**Re: 2536 Rochester Road
Response to PRC Comments**

2759

On behalf of the applicant, Apogee Development LLC, we have reviewed the comments from MRB Group (dated July 23, 2021), Town of Farmington Water & Sewer (dated July 9, 2021), the City of Canandaigua Fire Department (dated July 1, 2021), the NYS Department of Transportation (dated June 23, 2021), the Ontario County Planning Board Meeting (dated July 14, 2021), and the recommendations from the ECB draft meeting minutes (dated July 8, 2021) for the above-referenced project, and have the following responses for the Town's consideration:

DRAWING TITLE
TURNING TEMPLATE (REFUSE)

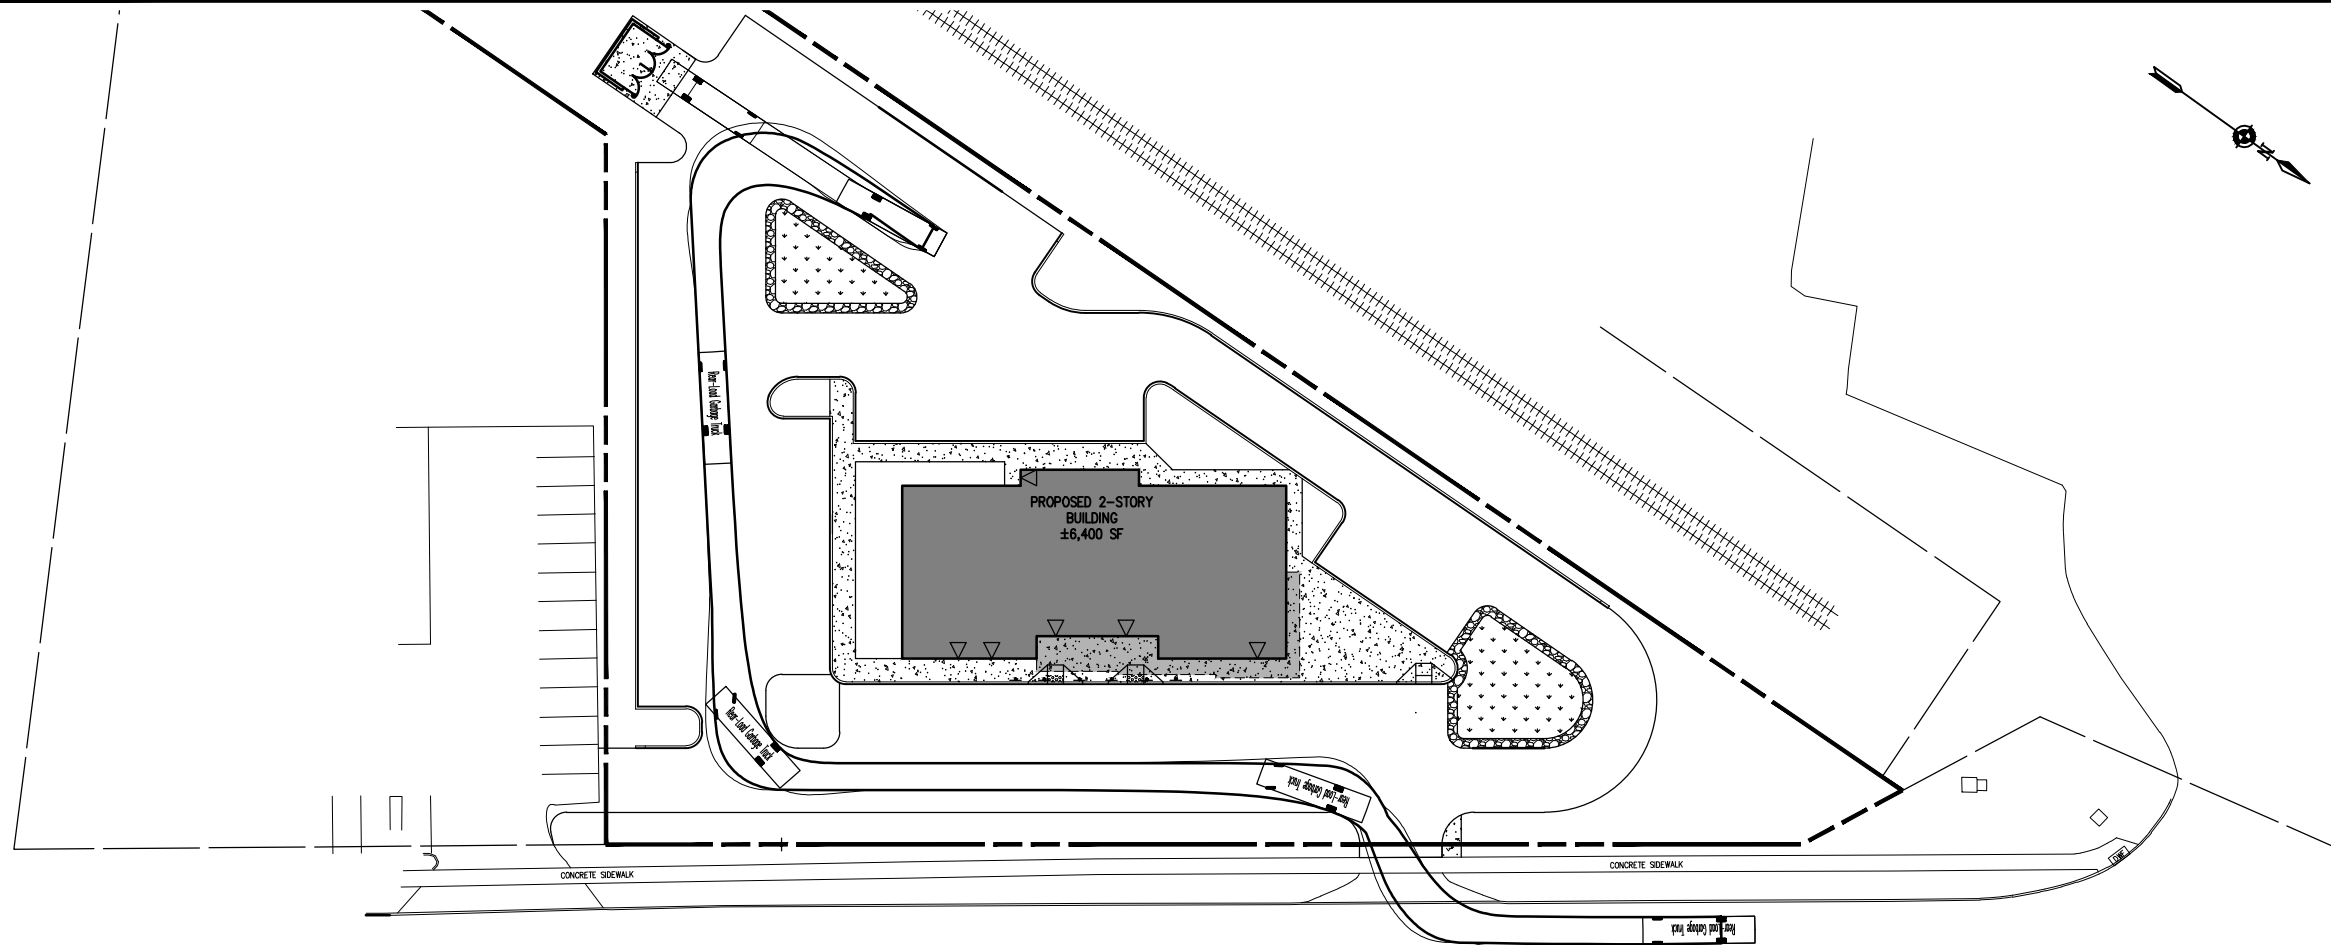
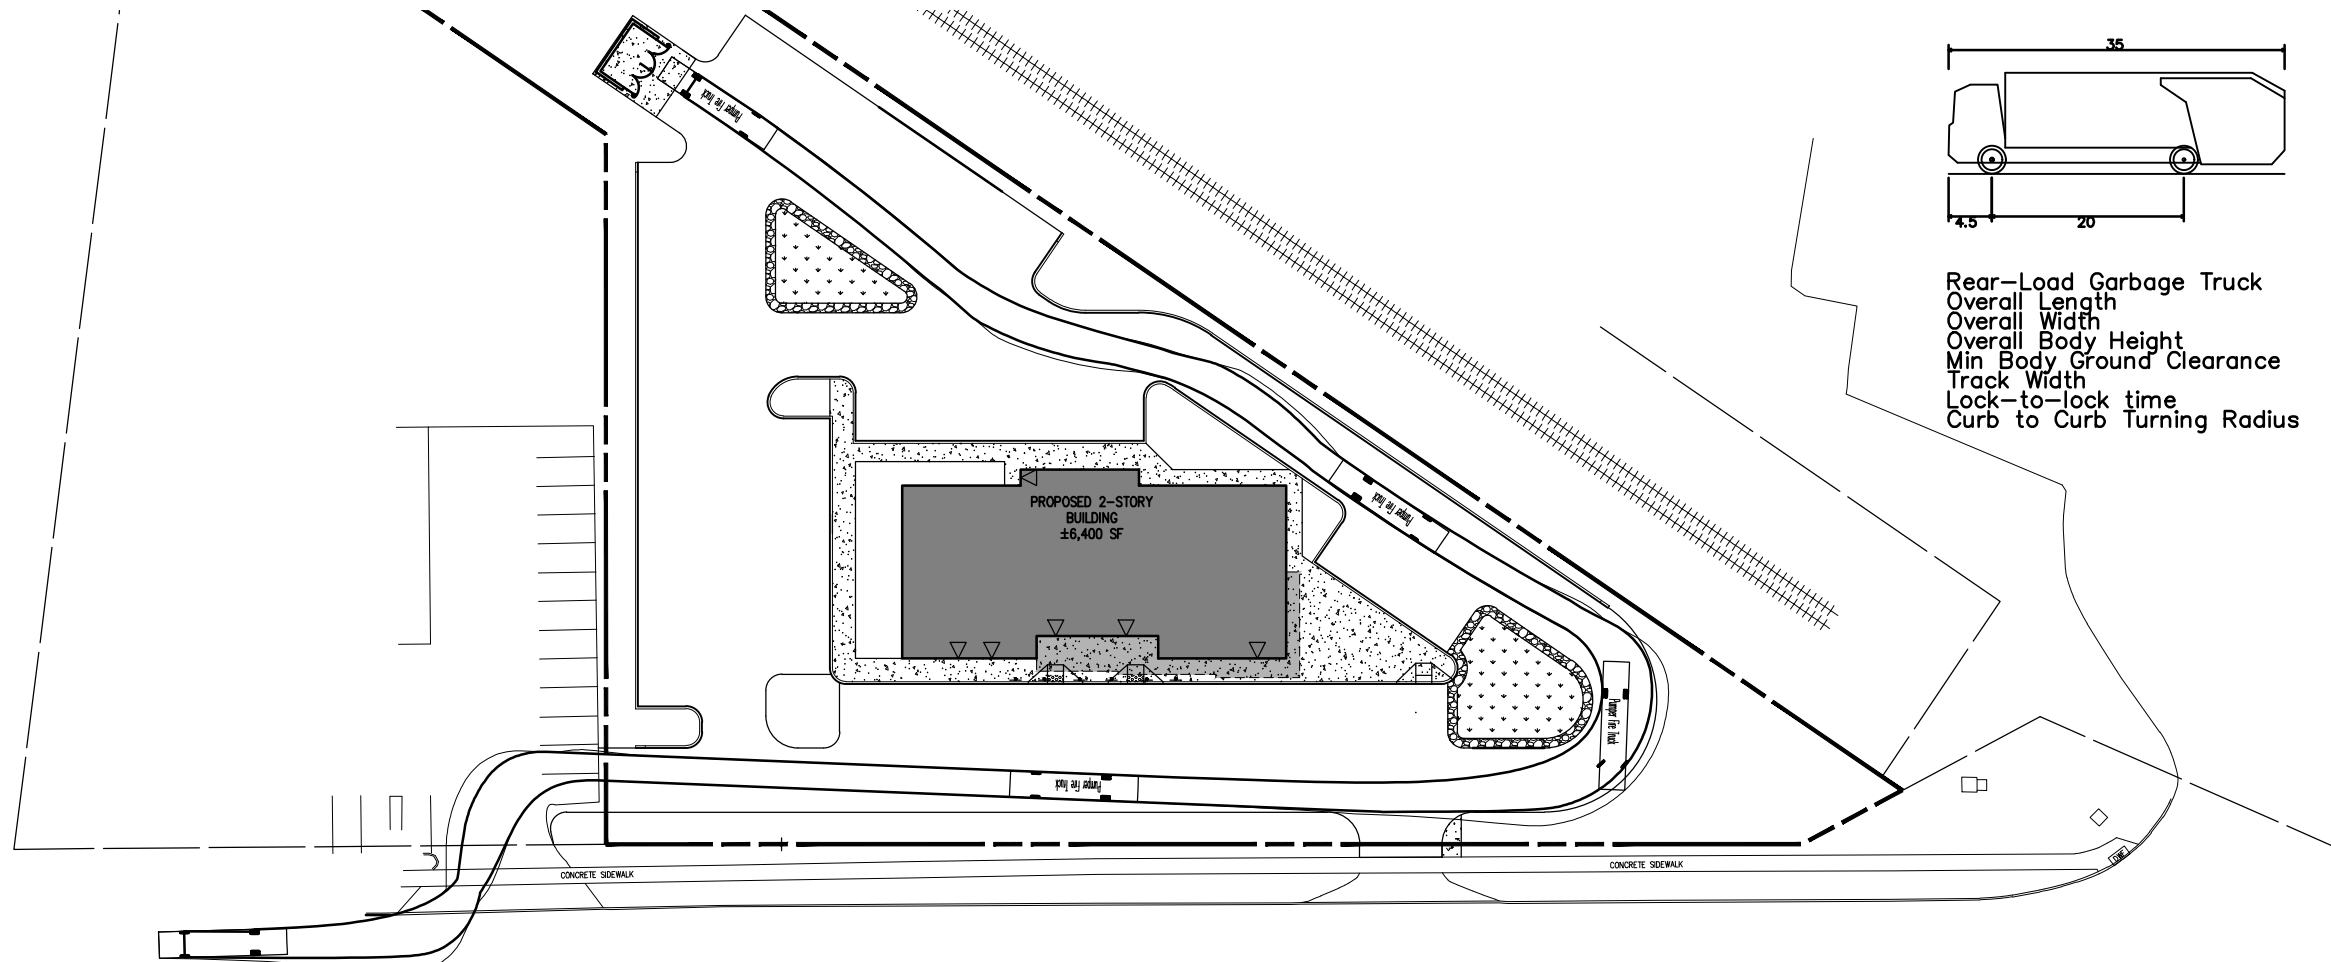
8. Vehicle turning movement analysis should be provided to demonstrate how a garbage truck will navigate to and from the proposed dumpster enclosure without intruding upon the bioretention area. Posts may need to be provided around said bioretention area to prevent intrusion.

A turning template for a rear load garbage truck has been included with this letter. The bio-retention areas are proposed with plantings to help create visual awareness of these areas within the parking lot.

Figure 5

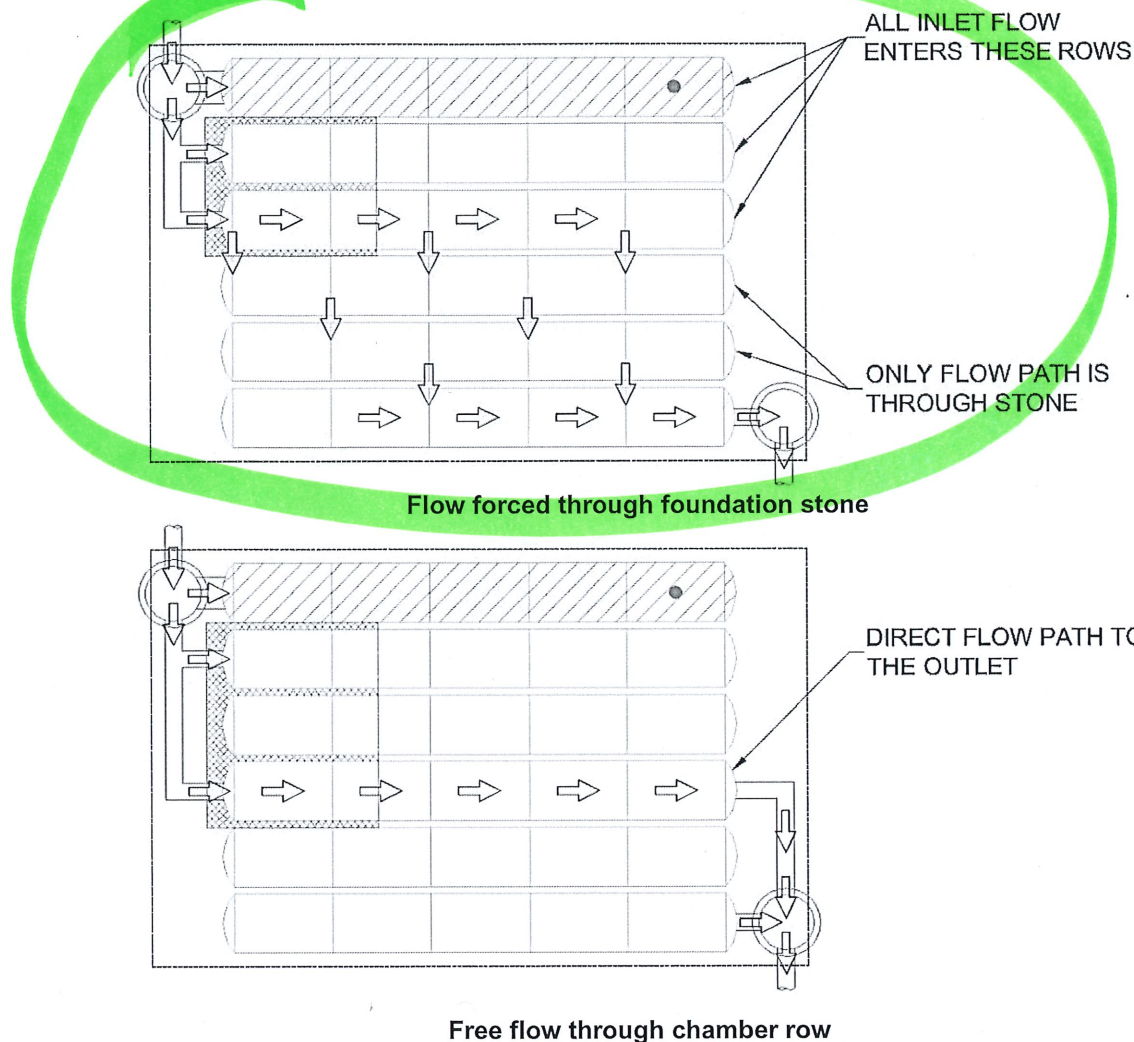
15. Will there be any interconnection between the storm chambers at the base invert, or only at the manifold invert?

The flow of stormwater through the system is strongly influenced by the surrounding stone media. The stone located immediately around the chambers is an integral part of the system composed of stone with a 40% porosity. The voids in the surrounding stone provide both storage and a path for water to flow between the chamber systems; as such the water level within the chambers will typically be the same as the water level in the surrounding stone. Attached is page #9 of StormTech Technical Note 6.32, which discusses flow paths through the stone layer. Table 5 on the document indicates there will be between 2.5cfs-6.67cfs of flow per length of MC-3500 chamber (14 for the proposed configuration) while using a #3 / #4 stone gradation, which is indicated in the details provided on drawing #2759-15. Thus, for the type of the system proposed, additional manifolds are not necessary as the stone, as intended by the manufacturer, will disperse the inflow through the system.
